**GEOPROBE INVESTIGATION  
SUMMARY REPORT**

**BRINKERHOFF ROAD FACILITY  
KANSAS CITY, KANSAS**

**UNION CARBIDE CORPORATION  
3200 KANAWHA TURNPIKE  
SOUTH CHARLESTON, WEST VIRGINIA**

**October 16, 1995**

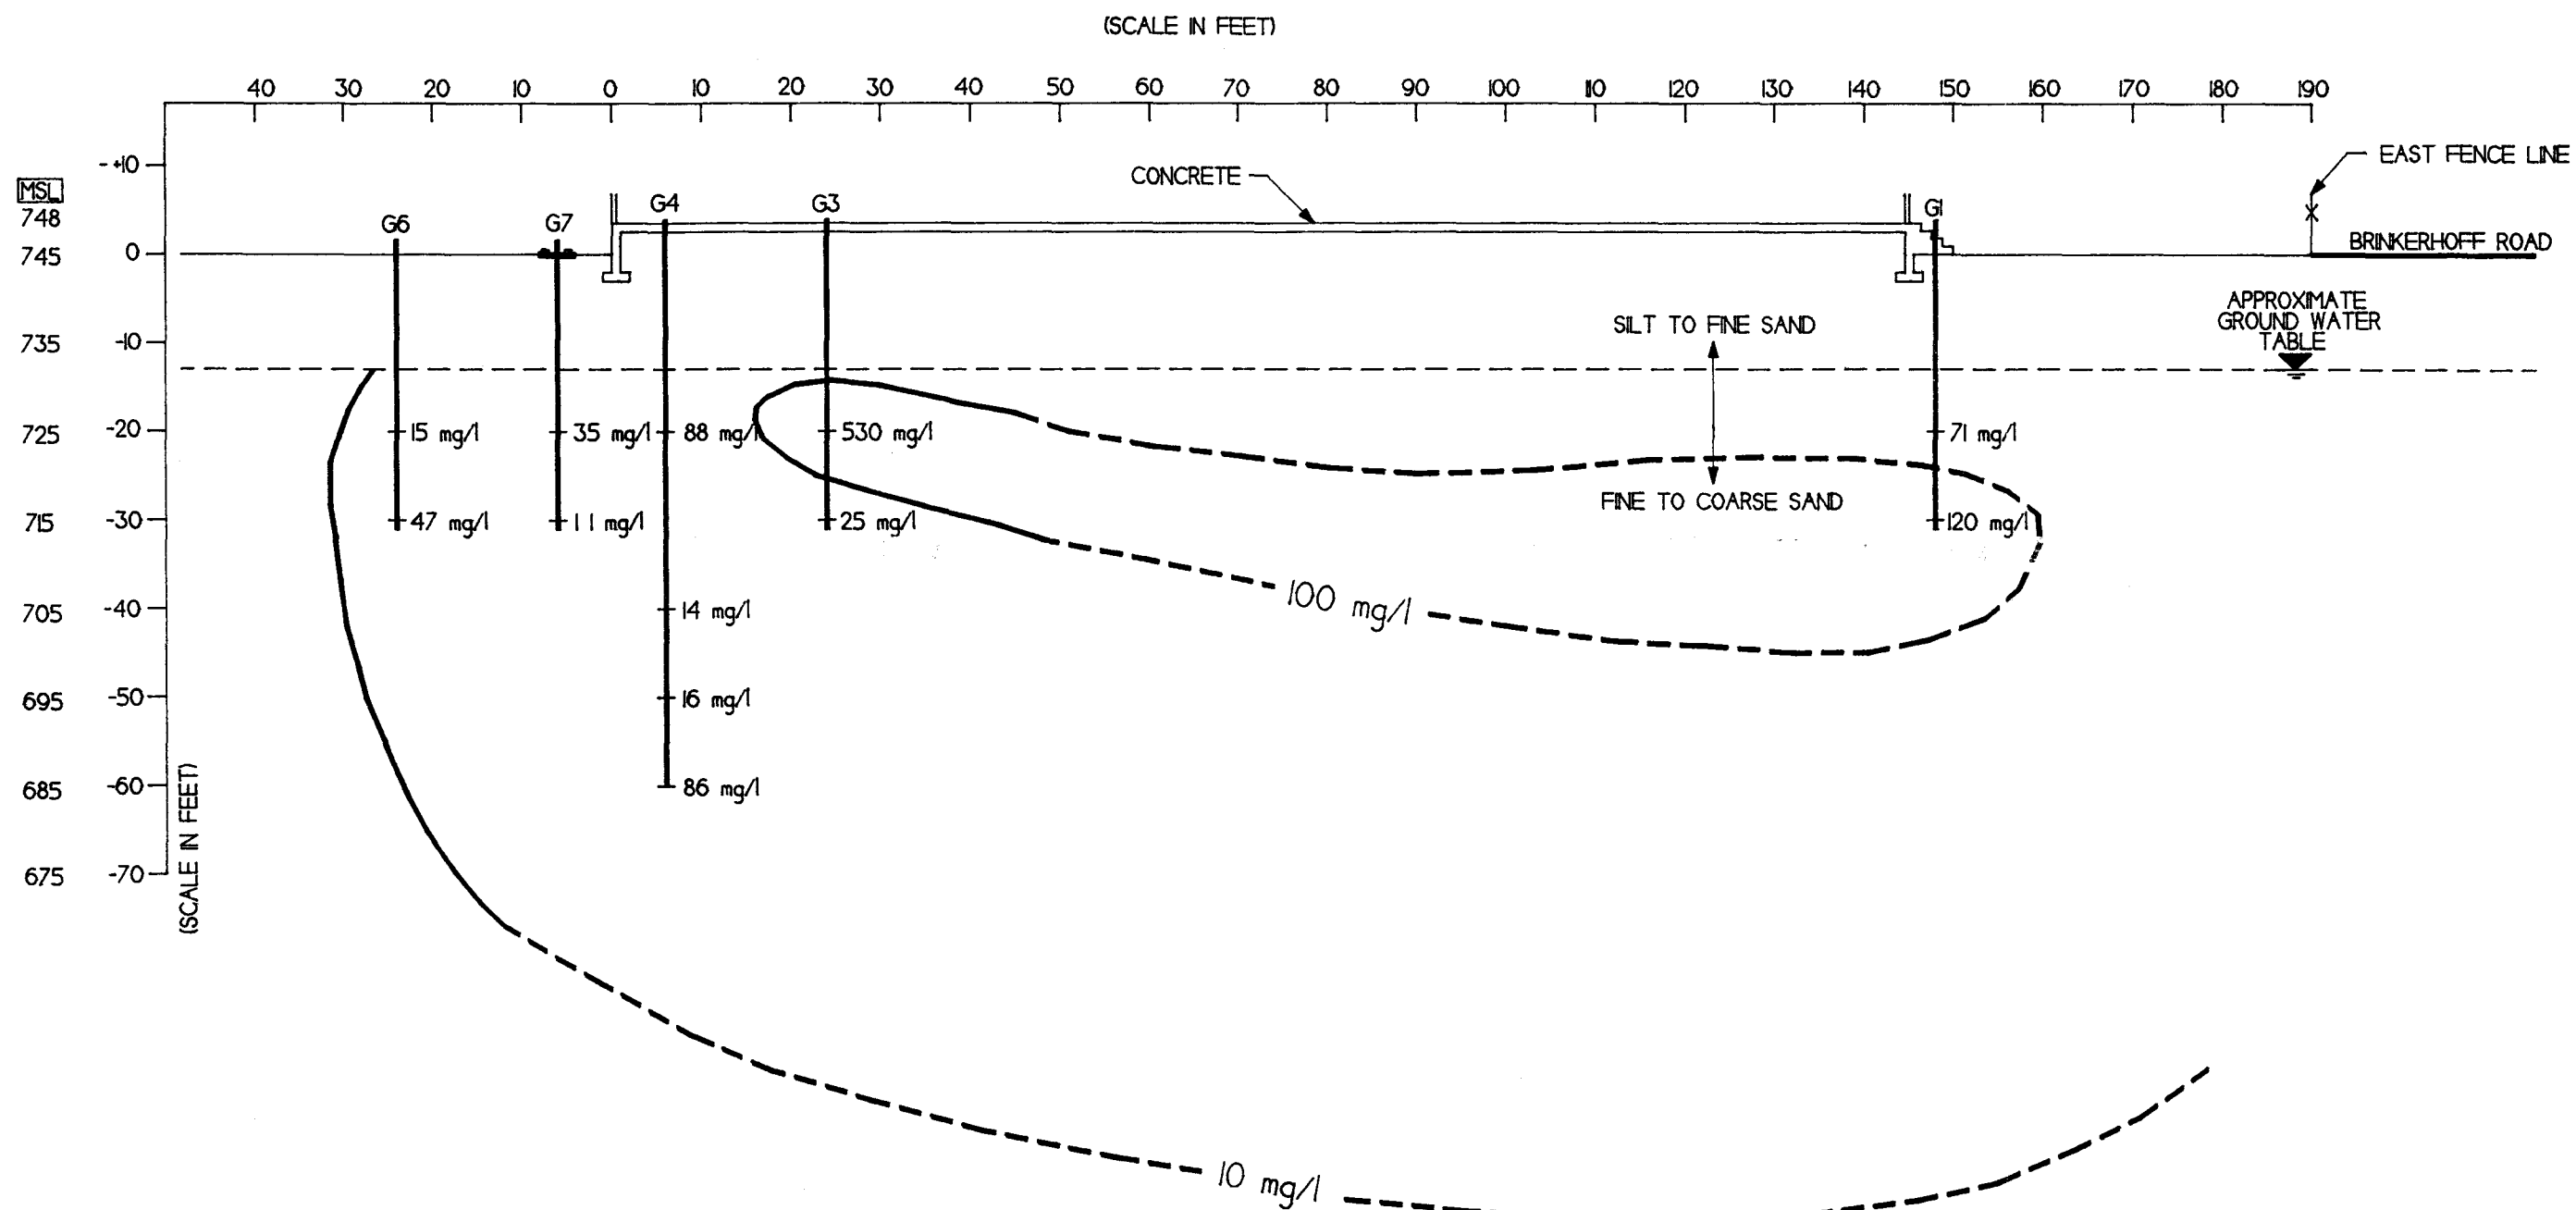
Previous sampling showed  
9.6 ppm <sup>TE</sup> in MW-14A

contours  
are way  
too optimist  
i.e., distance  
between 100 mg/L  
line + G1 +  
10 mg/L line
